Intel[®] 815 Chipset Platform

Design Guide Update

Document Number: 298250-002

Figure 59. Clock Routing Topologies

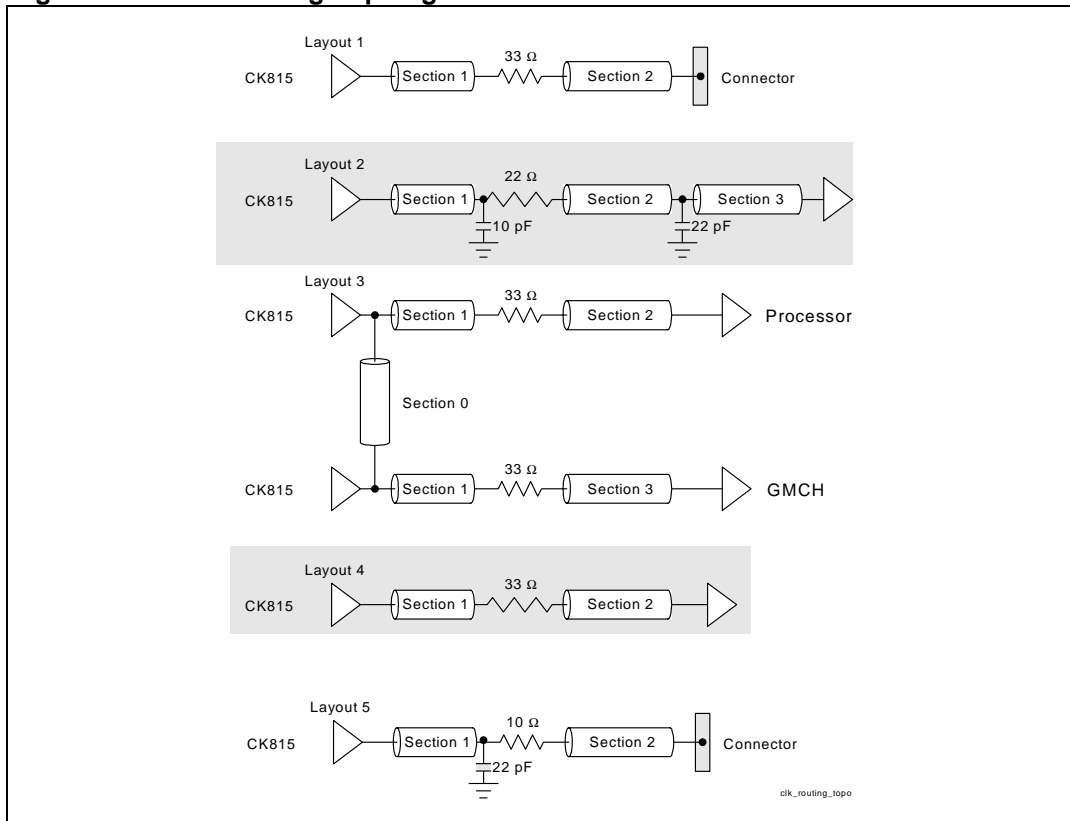
1. Changed: Clock Routing Guidelines, Section 10.3; New Layout Guidelines for SDRAM, SCLK, and GMCH HCLK

These new clock guidelines are for future designs to improve PC133 SDRAM Clock Quality. Replace Section 10.3 with the following:

This section presents the generic clock routing guidelines for both 2-DIMM and 3-DIMM boards. For 3-DIMM boards, additional analysis must be performed by the motherboard designer to ensure that the clocks generated by the external PCI clock buffer meet the PCI specifications for clock skew at the receiver, when compared with the PCI clock at the ICH.

Destination	Topology from Previous Figure	Section 0 Length	Section 1 Length	Section 2 Length	Section 3 Length
SDRAM MCLK	Layout 5	N/A	< 0.5"	A ¹	N/A
GMCH SCLK ³	Layout 2	N/A	< 0.5"=L1	A + 3.5" – L1	0.5"
Processor BCLK	Layout 3	< 0.1"	< 0.5"	A + 5.2"	A + 8"
GMCH HCLK			<0.5"		
GMCH HUBCLK	Layout 4	N/A	<0.5"	A + 8"	N/A
ICH HUBCLK	Layout 4	N/A	<0.5"	A + 8"	N/A
ICH PCICLK	Layout 4	N/A	<0.5"	A + 8"	N/A
AGP CLK	Layout 4	N/A	<0.5"	A + 3" to A + 4"	N/A
PCI down ²	Layout 4	N/A	<0.5"	A + 8.5" to A + 14"	N/A
PCI slot ²	Layout 1	N/A	<0.5"	A + 5" to A + 11"

1. Length "A" has been simulated up to 6".
2. All PCI clocks must be within 6" of the ICH PCICLK route length. Routing on PCI add-in cards must be included in this length. In the presented solution space, ICH PCICLK was considered to be the shortest in the 6" trace routing range, and other clocks were adjusted from there. The system designer may choose to alter the relationship of PCI device and slot clocks, as long as all PCI clock lengths are within 6". Note that the ICH PCICLK length is fixed to meet the skew requirements of ICH PCICLK to ICH HUBCLK
3. 22 pf Load cap should be placed 0.5" from GMCH Pin.

- All clocks should be routed 5 mils wide with 15-mil spacing to any other signals.
- It is recommended to place capacitor sites within 0.5" of the receiver of all clocks. They are useful in system debug and AC tuning.
- Series resistor for clock guidelines: 22 Ω for GMCH SCLK and 10 Ω for SDRAM clocks. All other clocks use 33 Ω .
- Each DIMM clock should be matched within ± 10 mils.
